Review of existing conditions related to buffering of residential property v proposed site plan AR#32920.

GDC JN 23-05
Comment Response

SUBJECT: Alien Engineered Products - Shop Expansion
Project Number - #2025050081
Application: Major Site Plan #32920
Comment Responses – DRAFT- INTENT OF RESPONSES – PENDING DRC

2024 Aerial Map

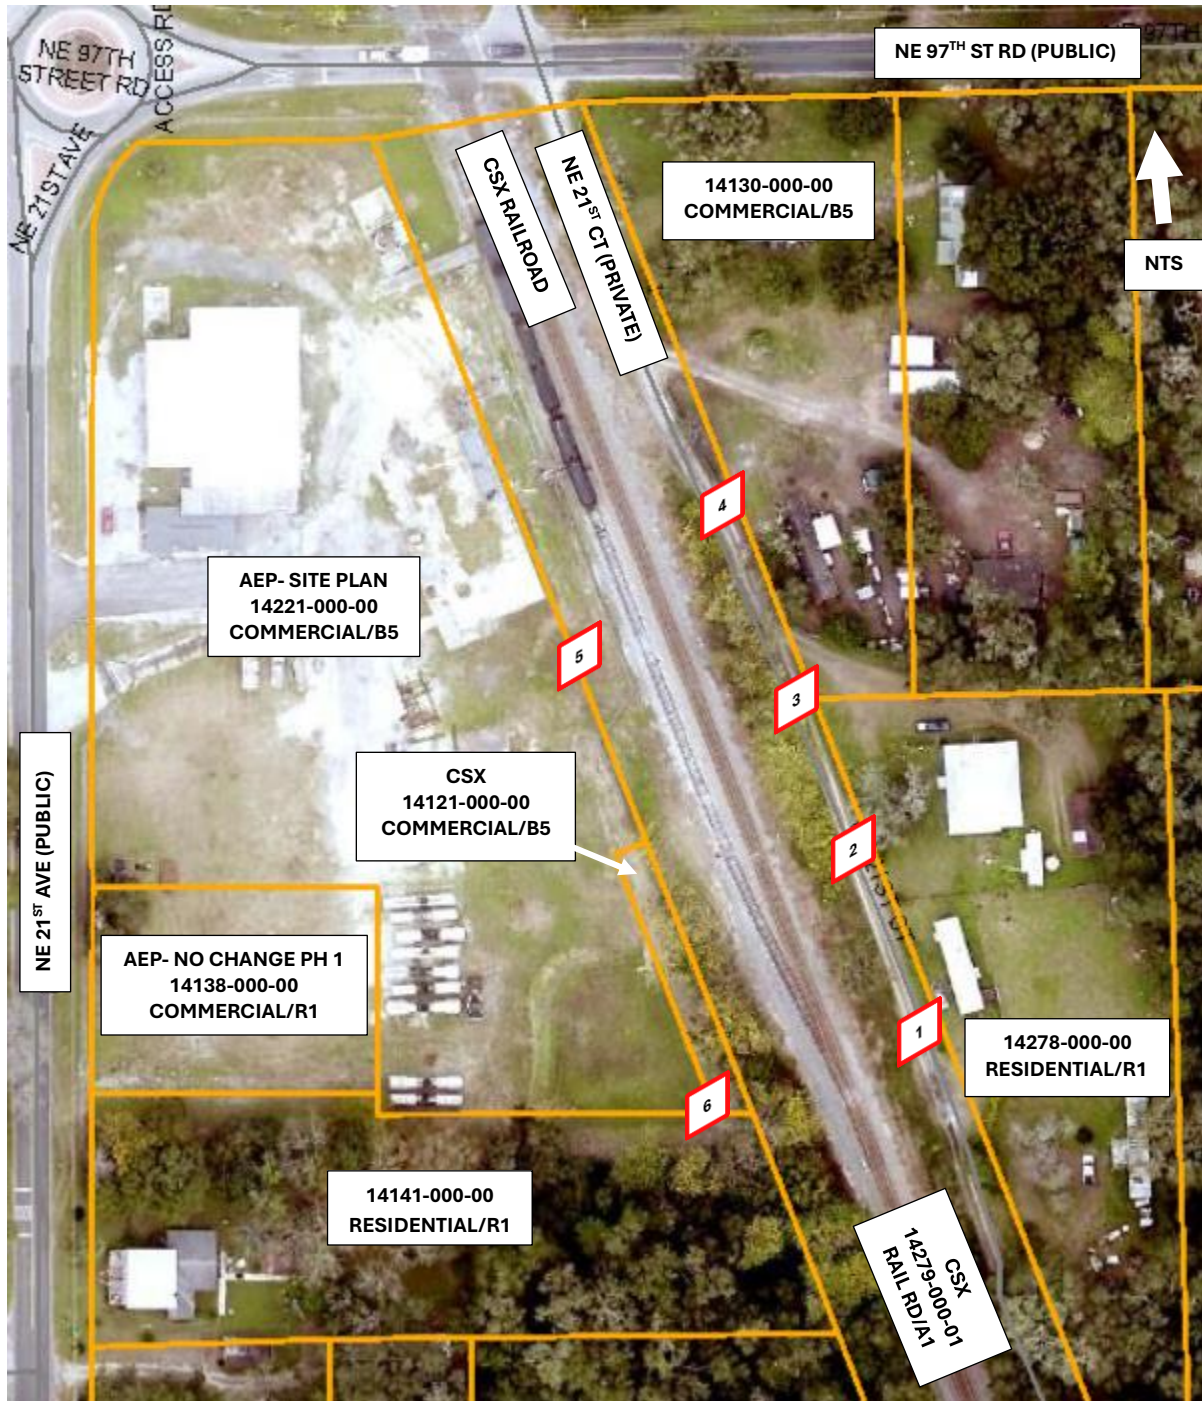
See Photo ID# references below.
